# PARKER AND PINE RETAIL PINE LANE AND S. PARKER ROAD SITE PLAN

**SITE PLAN SUBMITTAL**

Sheet Title:  
**LANDSCAPE PLAN**  
 Date: 08/17/2017  
 Project Number: 096502001  
 Drawn By: STC  
 Sheet Number:

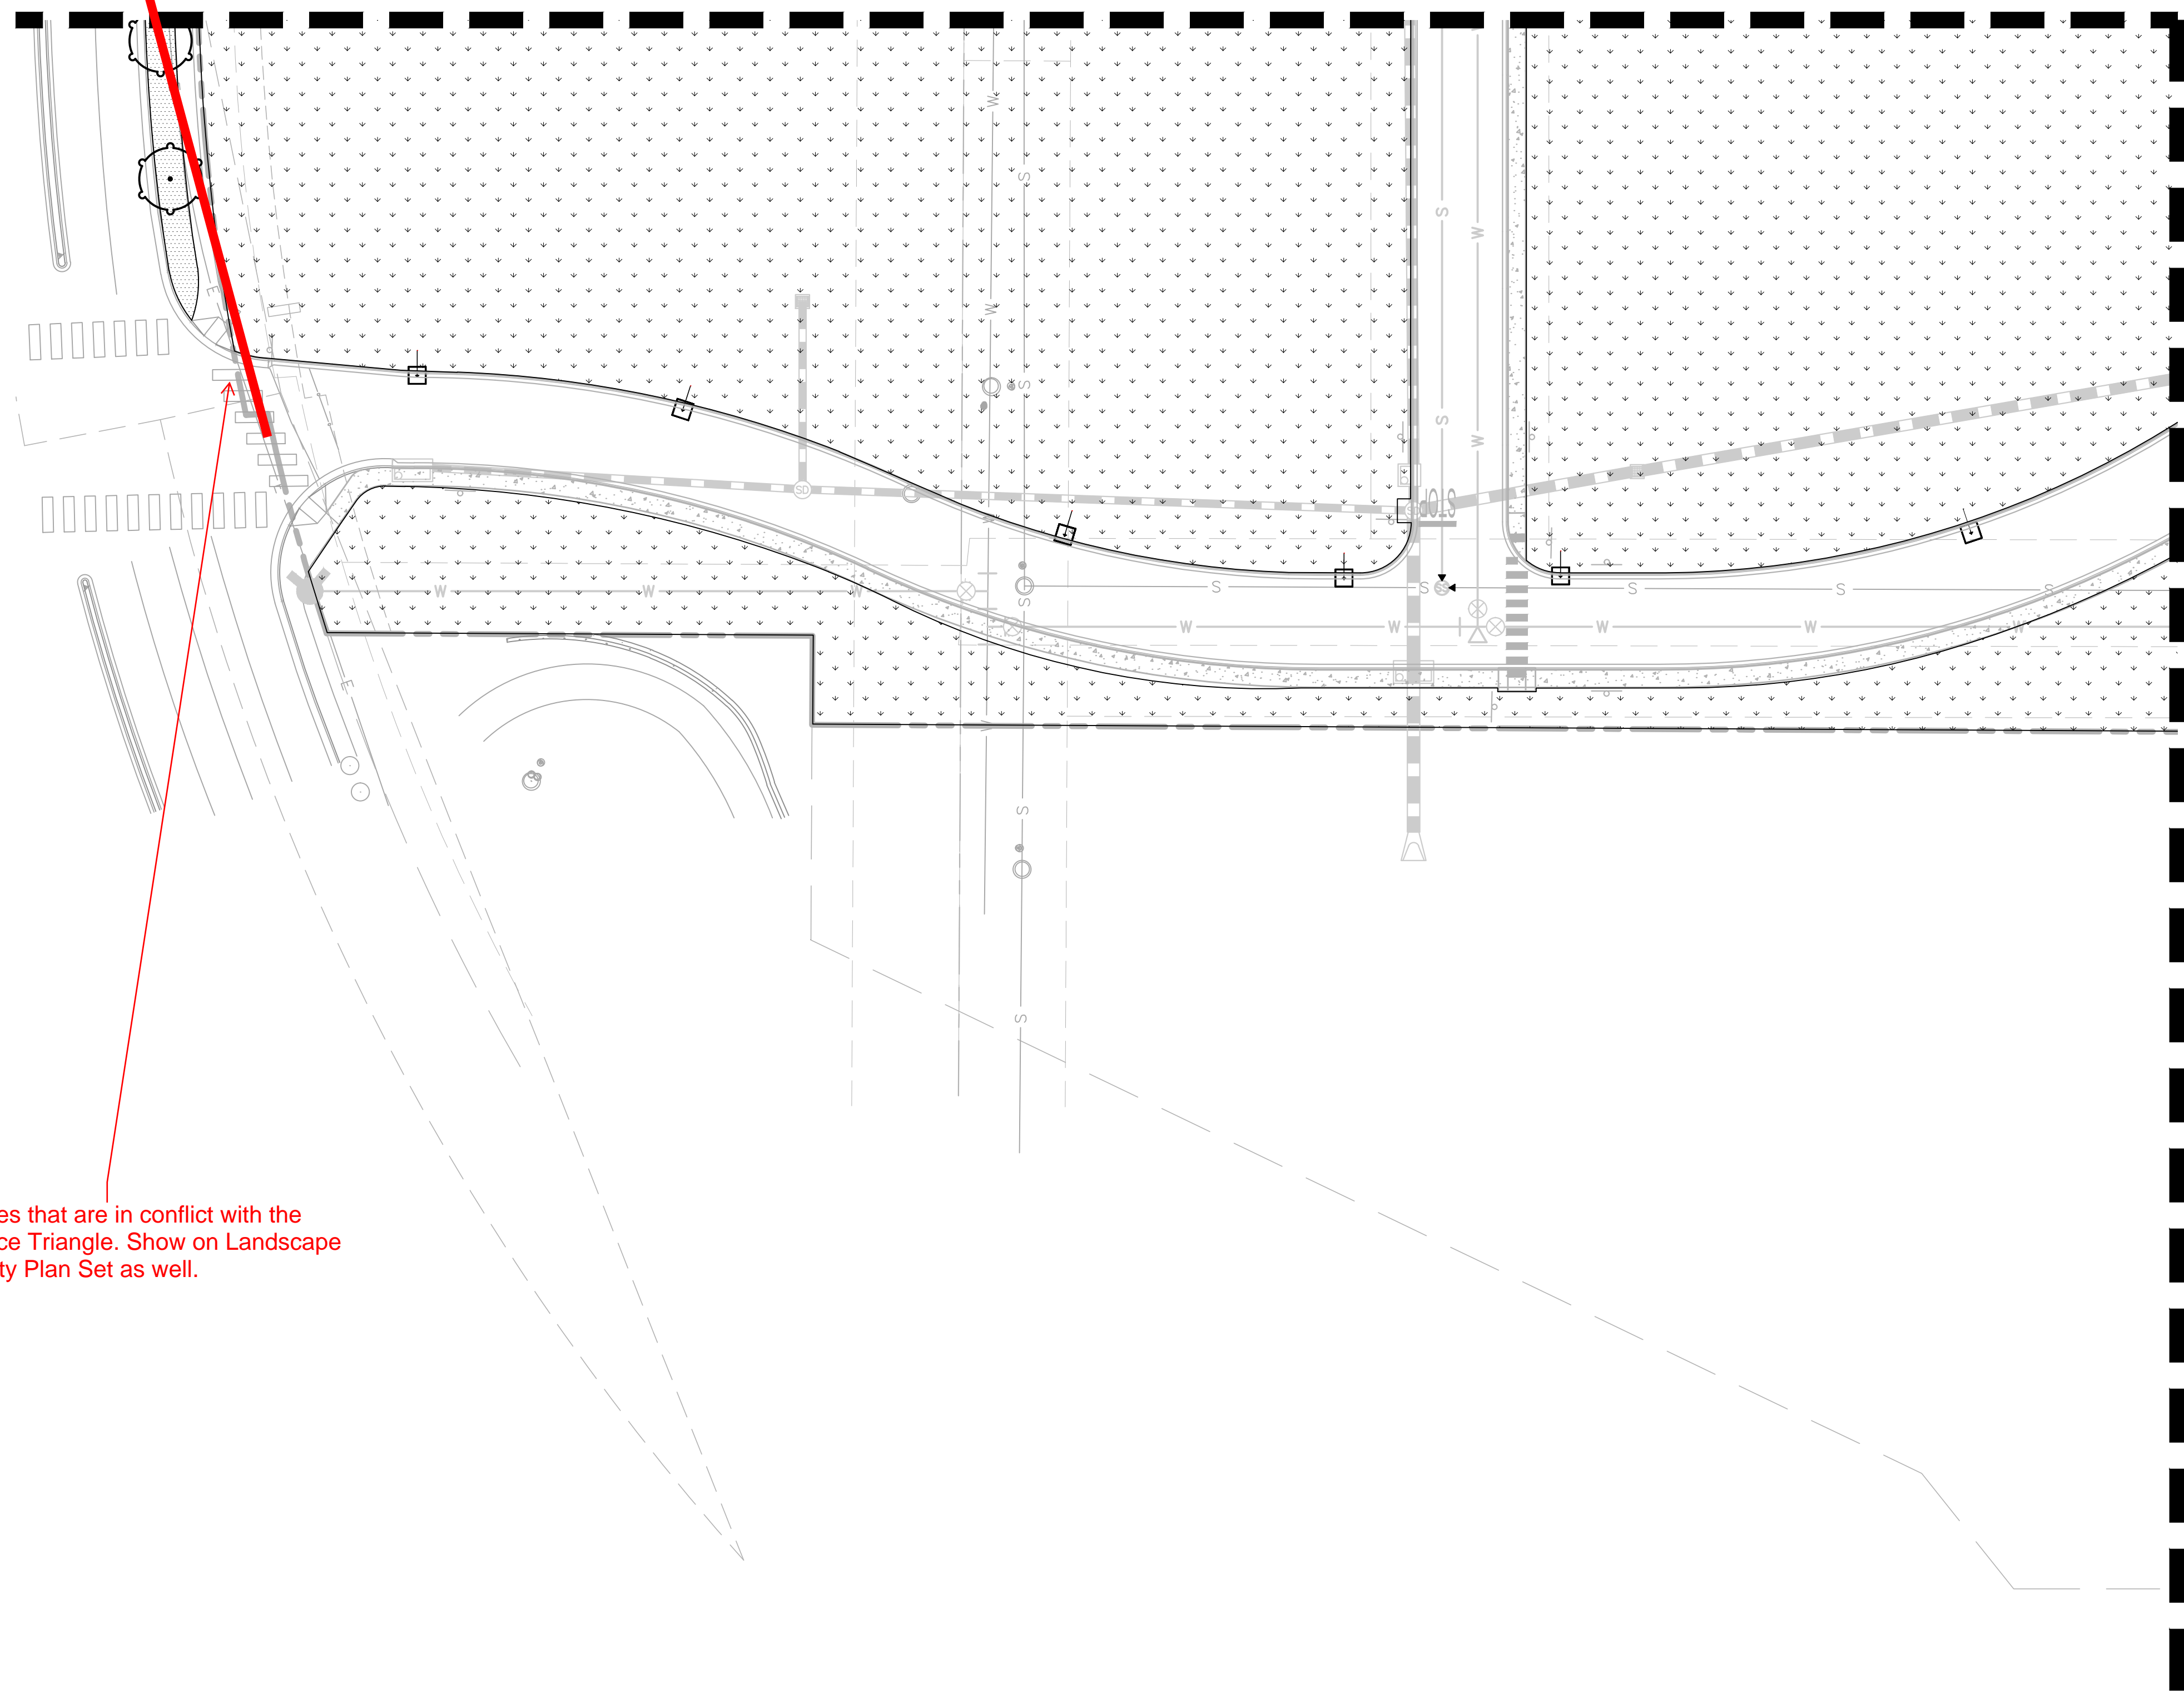
Relocate trees that are in conflict with the Sight Distance Triangle. Show on Landscape Plans in Utility Plan Set as well.

**07 OF 16**

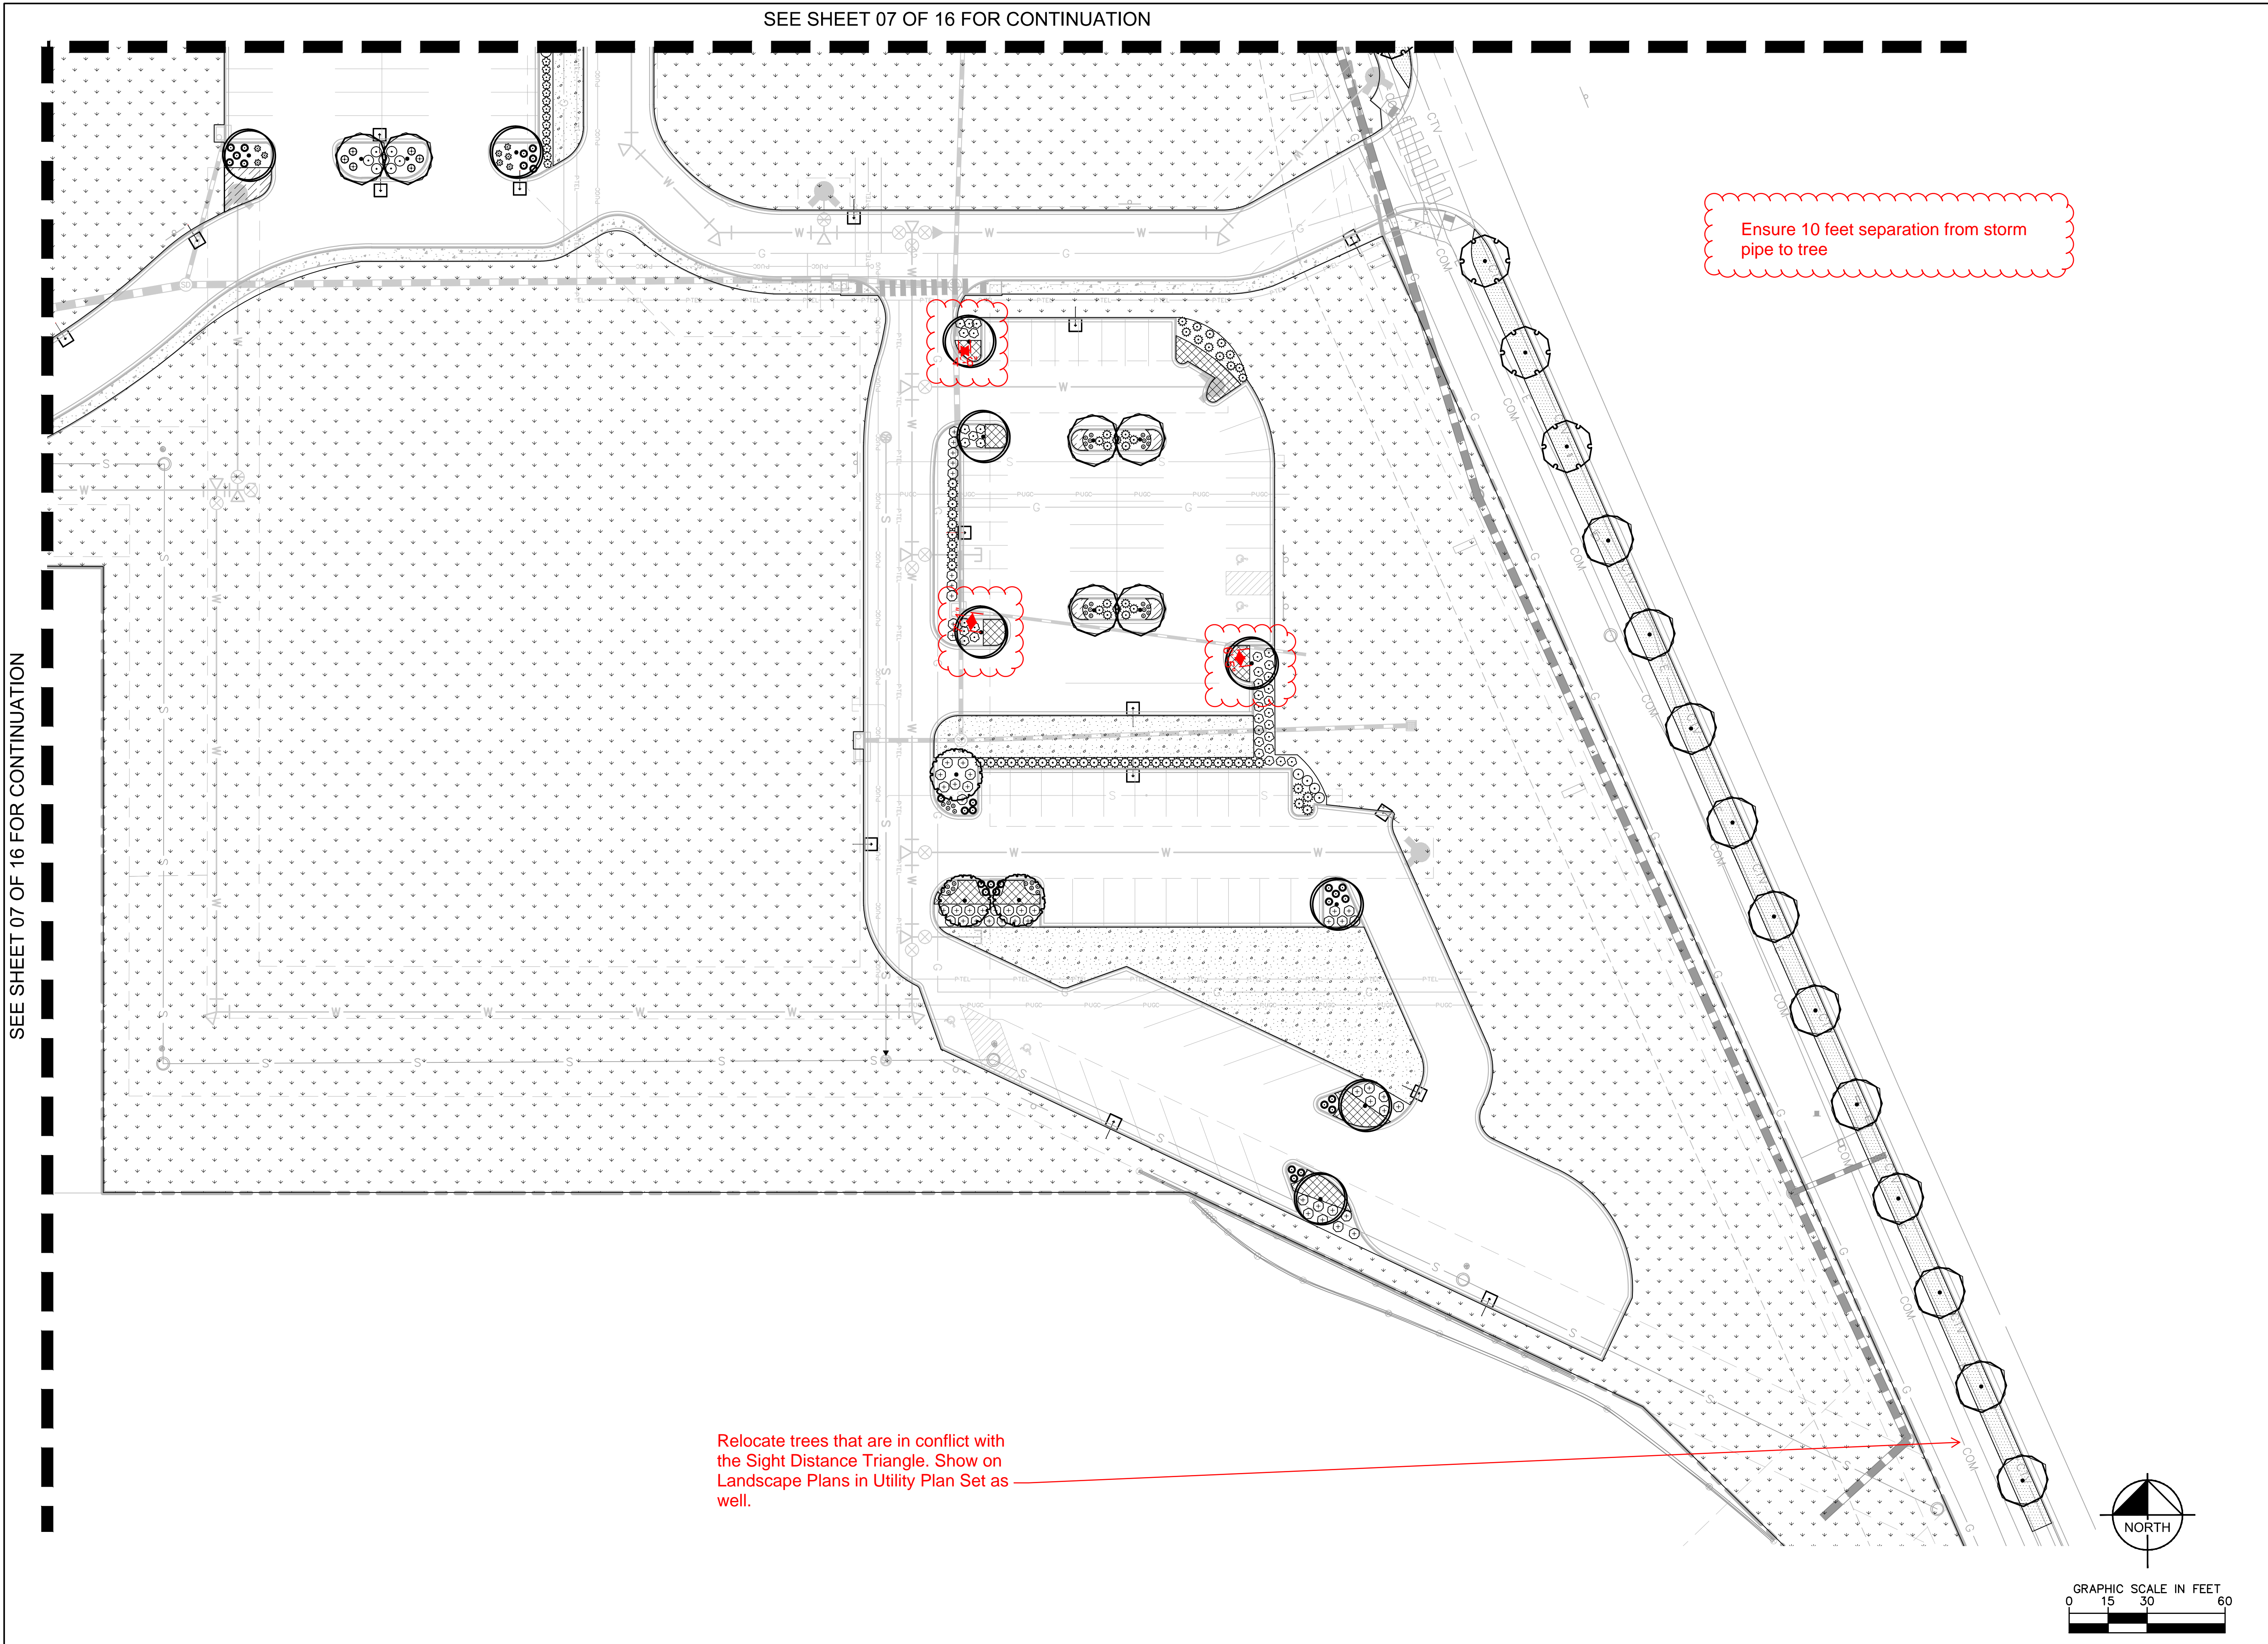
Ensure 10 feet separation from storm pipe to tree

Relocate trees that are in conflict with the Sight Distance Triangle. Show on Landscape Plans in Utility Plan Set as well.
